ADDENDUM 6 BID OPPORTUNITY 742-2005

WINNIPEG WATER TREATMENT PROGRAM – SUPPLY AND INSTALLATION OF WATER TREATMENT PLANT PROCESS MECHANICAL AND ELECTRICAL

ISSUED: May 30, 2006
BY: Bill Richert, P. Eng.
TELEPHONE NO. (204) 986-6053

Supernatant Pump System Curves

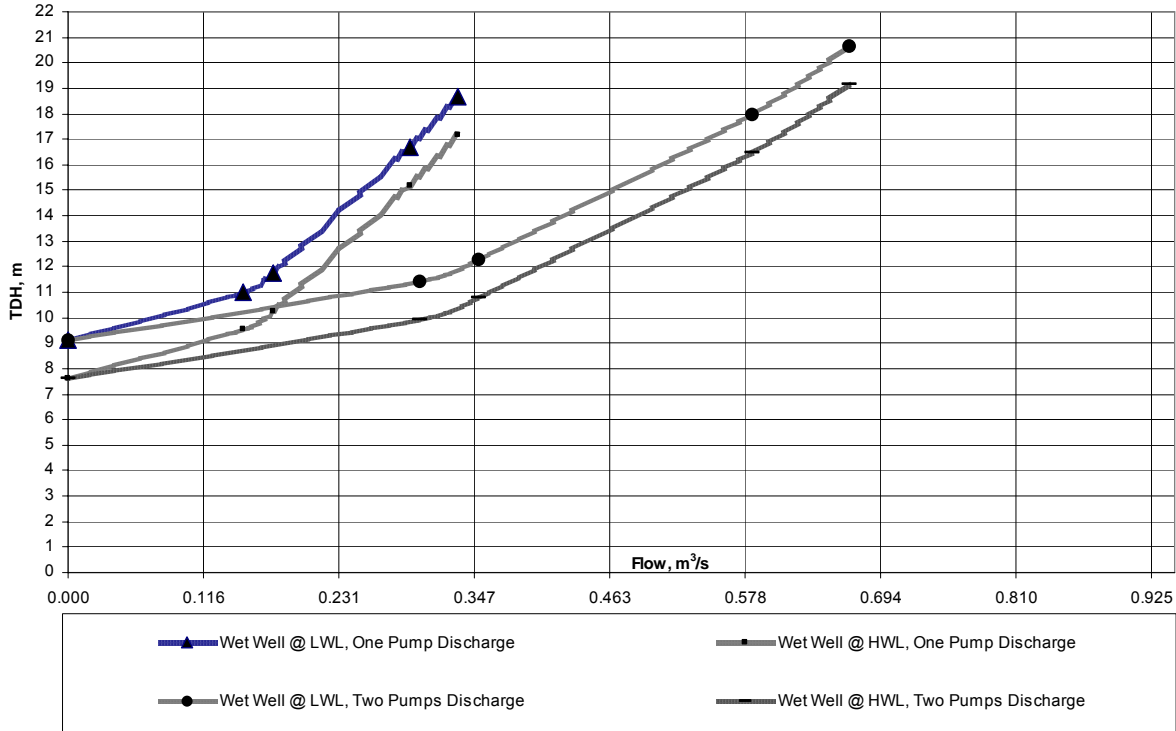
Revise: Supplement 2 to read:

SUPPLEMENT 2 – SUPERNATANT PUMP SYSTEM CURVES
